Report of the Chief Planning Officer

CITY PLANS PANEL

Pre-application presentation of revised proposals for redevelopment of Tower Works comprising 243 residential units, ground floor commercial floorspace and new public realm, Globe Road, Leeds (PREAPP/18/00291)

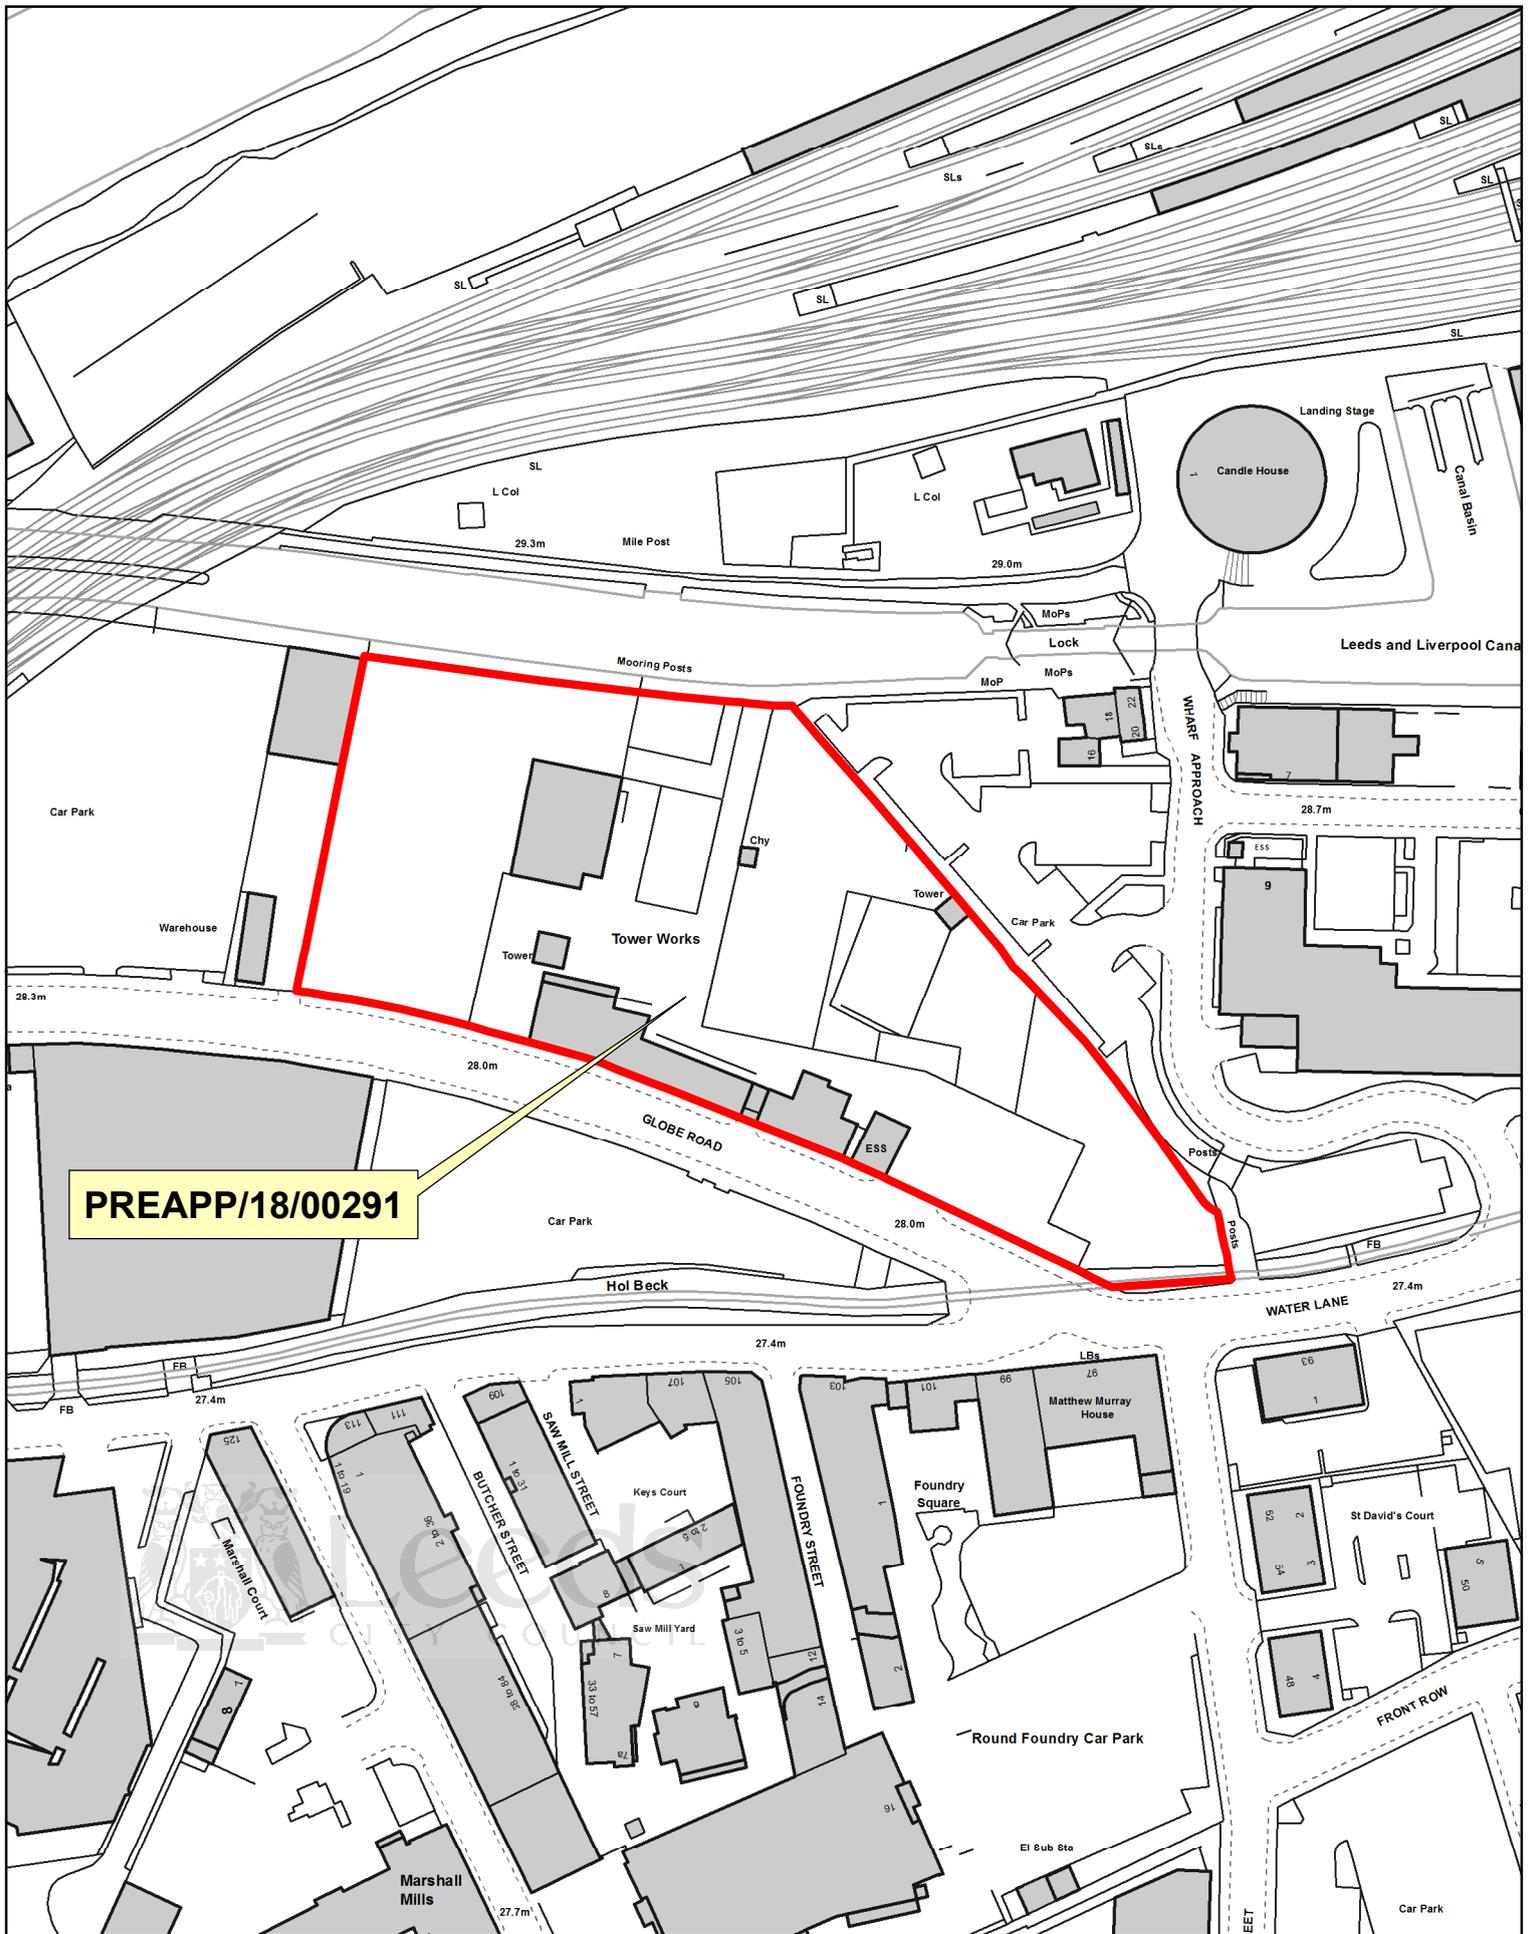
7.4.4 At the time of drafting this report the proposals showed the intent to remove hallways from within the proposed apartments, thereby providing direct access from communal corridors into the kitchen/living/dining rooms of the apartments. This arrangement reduces the gross apartment size by 4-6m²

Although the nett space would marginally increase relative to a standard apartment with a hallway the proposed approach would be such that the minimum floor areas identified in the NDSS, and forthcoming CSSR Policy H9, would not be achieved.

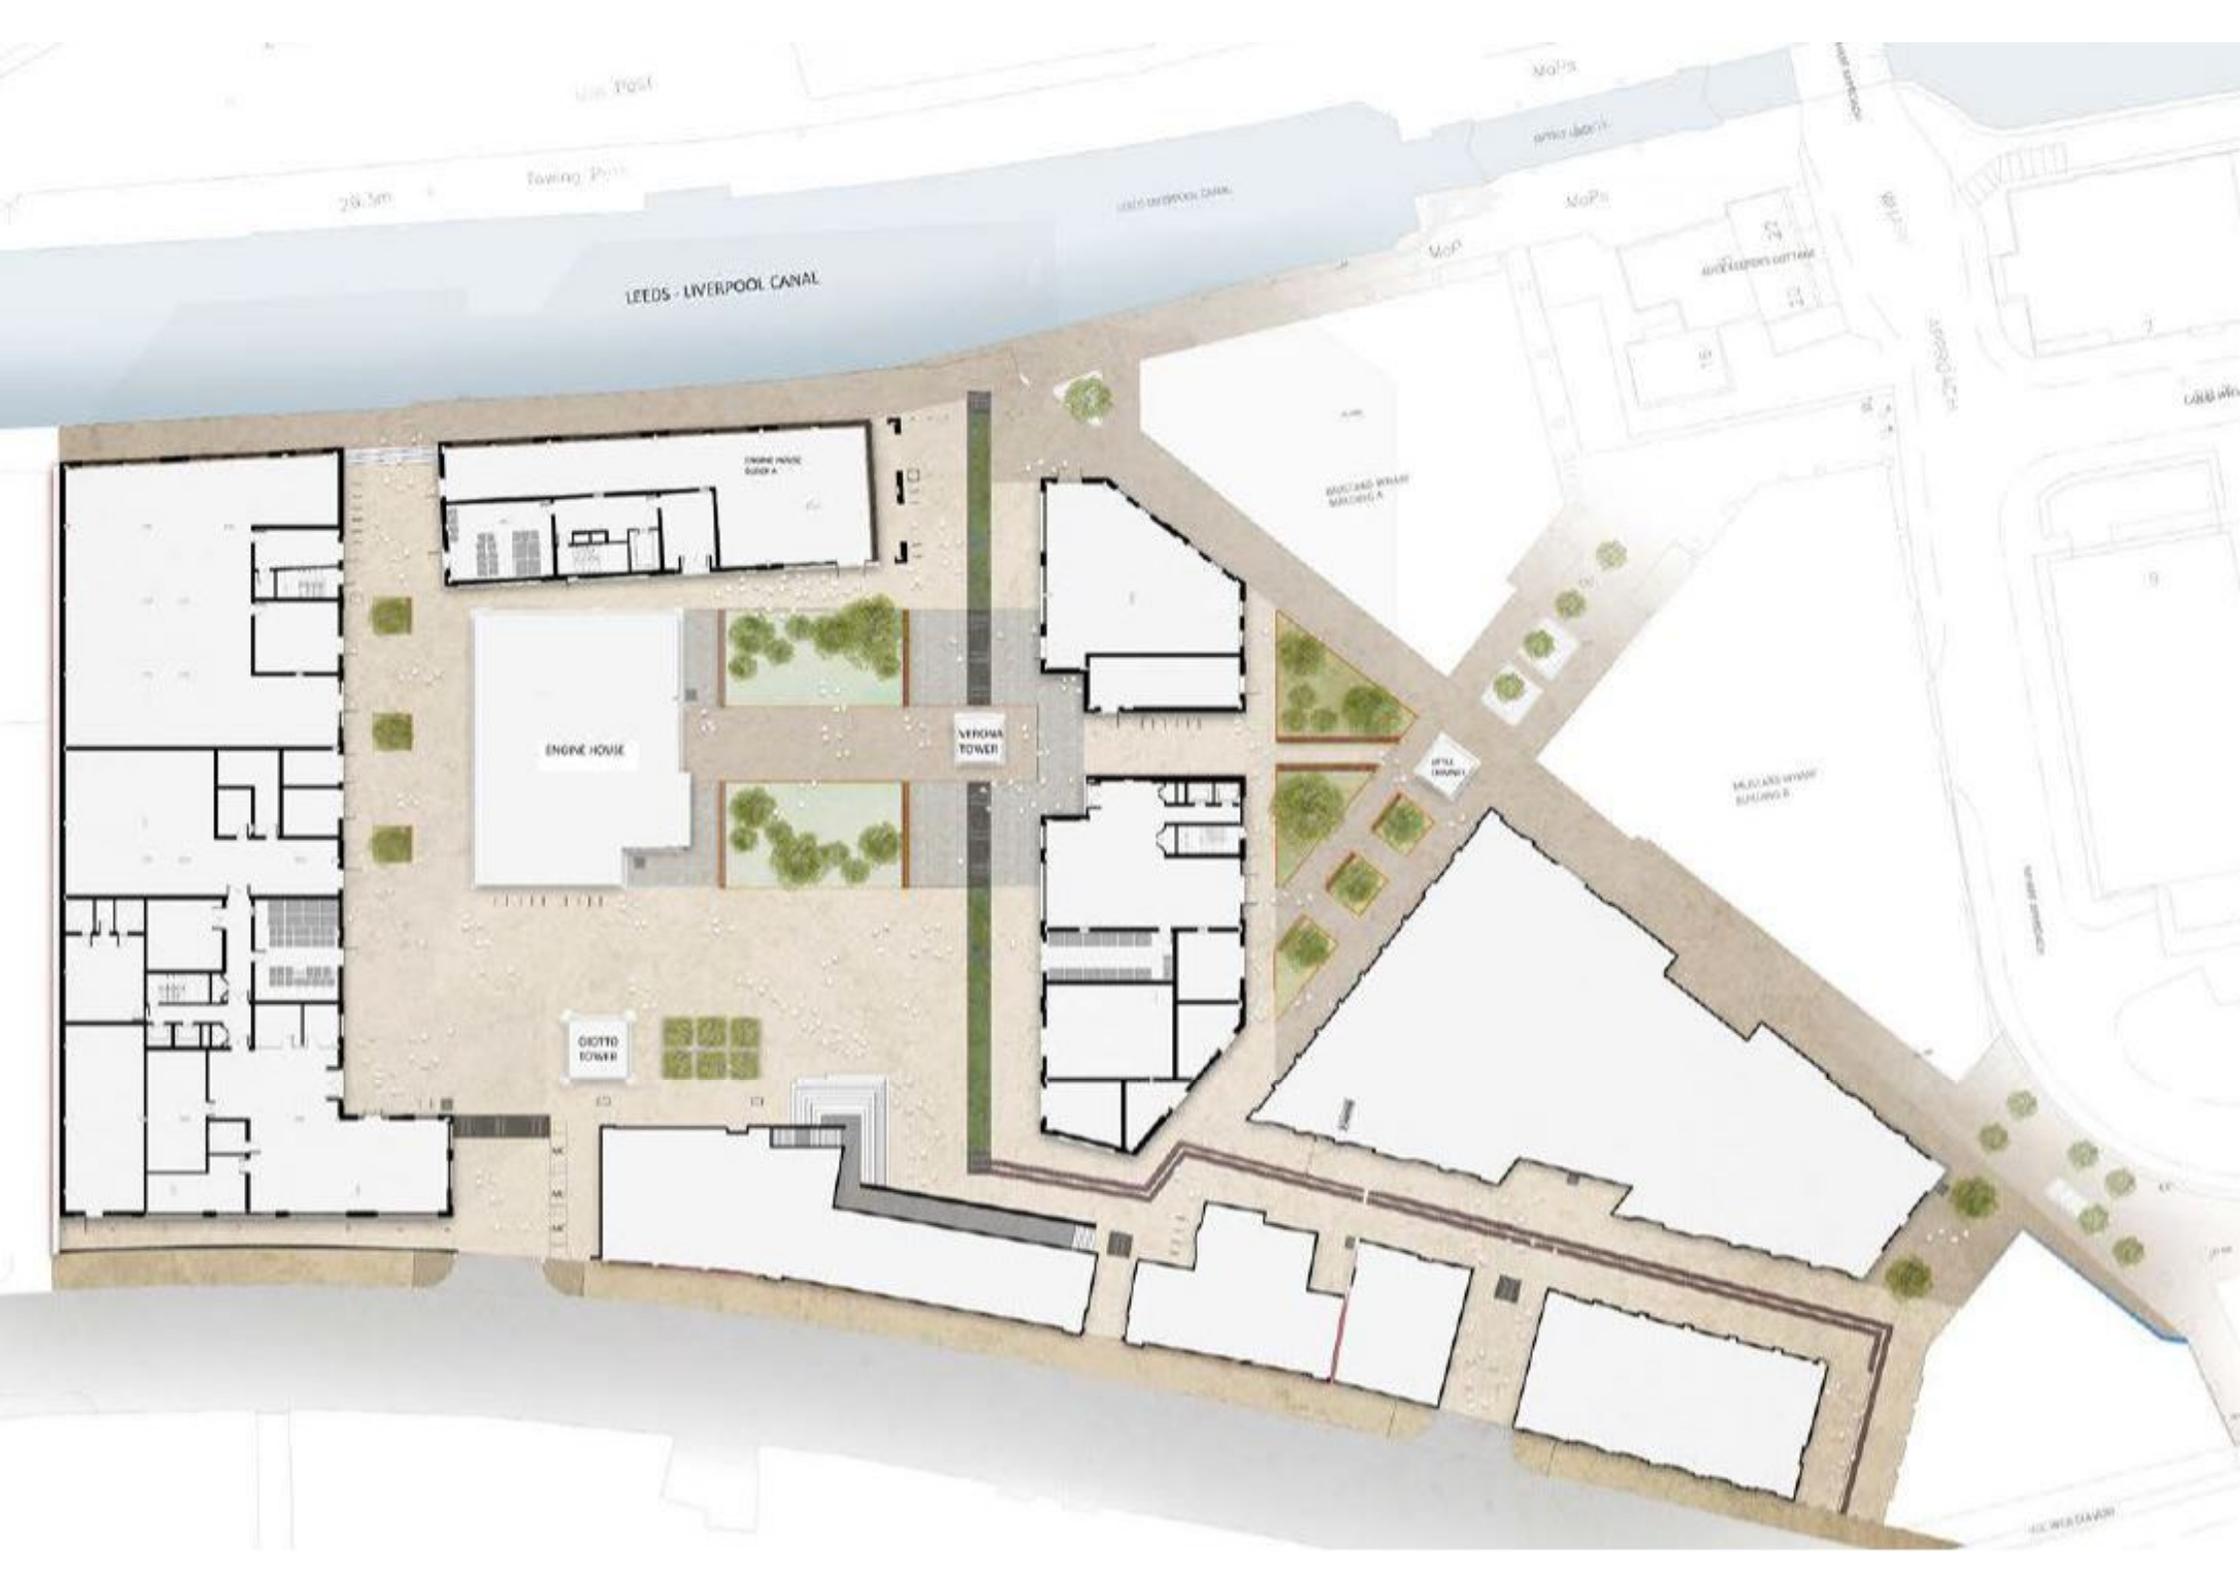
- 7.2.3 The current proposals are based upon the development of a simple wrap around the north and western boundaries of the site with a second building with a north-south axis running between the Verona Tower and Little Chimney. The intervening space

- 7.3.6 At the time of writing the public realm proposals identified the use of raised planters in spaces to the east of the Engine House and to the east of the Little Chimney. It is considered that such an approach would limit flexibility in the use of the spaces, create barriers to movement and also increase the maintenance requirements for these soft-landscaped areas. Consequently, officers consider that ground level lawns, landscaping and tree planting is more appropriate and, supported by load-bearing root zone cells in hard-surfaced areas, would provide more sustainable and higher-quality soft-landscaped spaces.
